DEVELOPMENT APPLICATION ASSESSMENT REPORT

Application Number:	DA2021/0053
----------------------------	-------------

Responsible Officer:	Jordan Davies
Land to be developed (Address):	Lot 7 DP 1251955, 121 Dove Lane WARRIEWOOD NSW 2102 Lot 1 DP 1266557, 111 Dove Lane WARRIEWOOD NSW 2102 Lot 4 DP 1251955, 101 Dove Lane WARRIEWOOD NSW 2102
Proposed Development:	Subdivision of land and construction of dwelling houses semi-detached dwellings and attached dwellings
Zoning:	R3 Medium Density Residential
Development Permissible:	Yes
Existing Use Rights:	No
Consent Authority:	Northern Beaches Council
Land and Environment Court Action:	No
Owner:	Morehuman Warriewood Pty Ltd
Applicant:	Craig & Rhodes Pty Ltd

The proposed development is for the staged 31 lot community title subdivision (undertaken in 2 stages) and construction of a total 31 residential dwellings, roads, drainage, landscaping and associated services for each lot.

Figure 1 - Site plan of garages setback SM1 and SM3

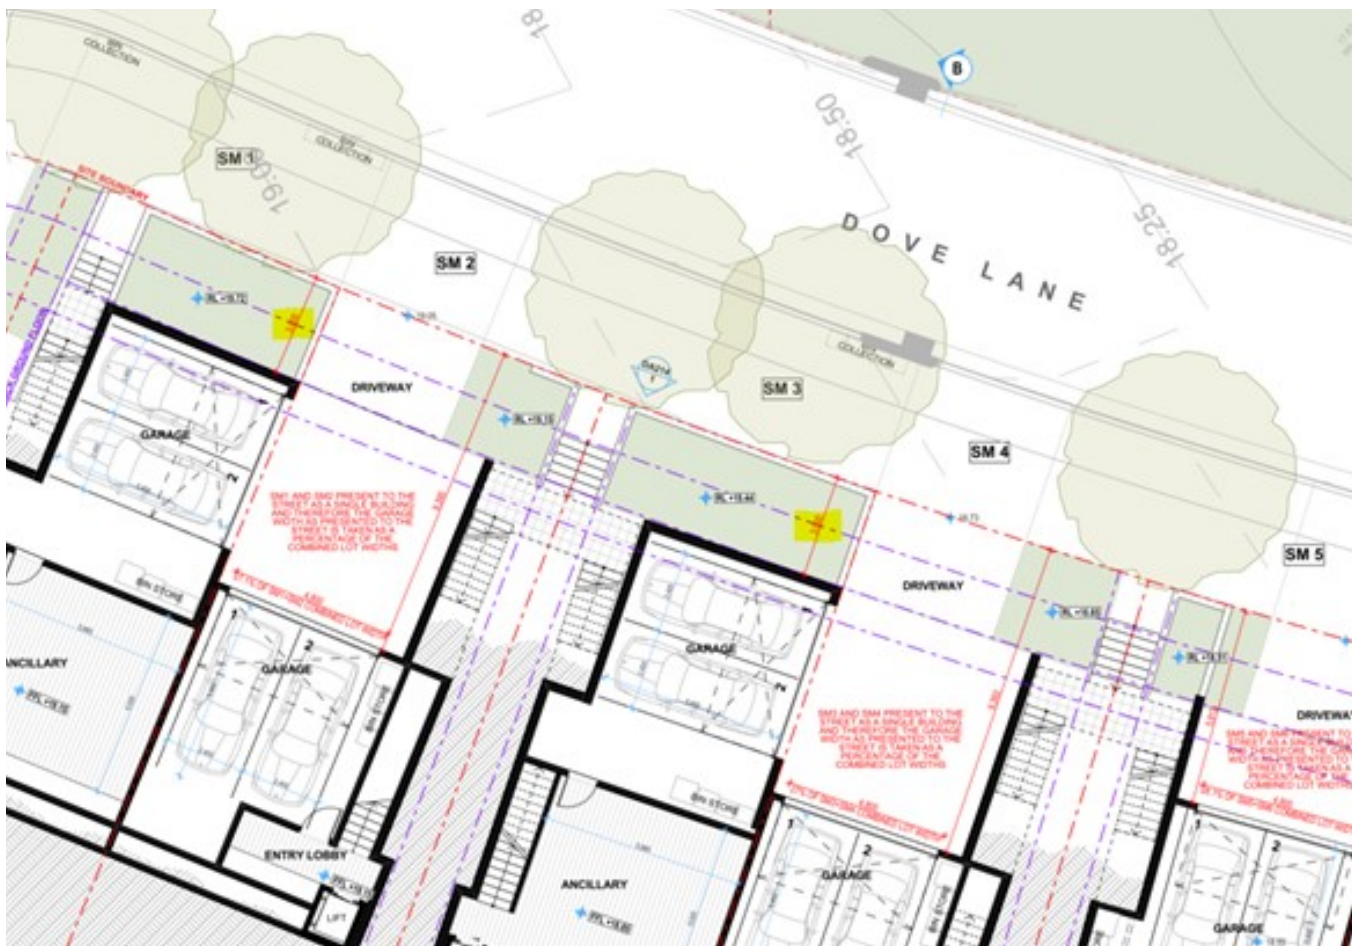
The DCP requires a front setback of 4m to the garage a dwelling when it is facing a road (other than a laneway). All of the garages to the front loaded dwellings provide a minimum 4m setback with the exception of SM1 and SM3 (semi-detached dwellings). These semi-detached dwellings use a shared driveway arrangement to provide a double garage for each dwelling whilst limiting the visual presence of garages fronting the street. This specific issue was considered by the DSAP where the following comment was made of this arrangement:

Council agrees with the above comment with regards to the setback of the garages for semi-detached dwelling SM1 and SM3 and this element of the garage does not present a garage door to the street, with side loaded garages provided via a shared driveway.
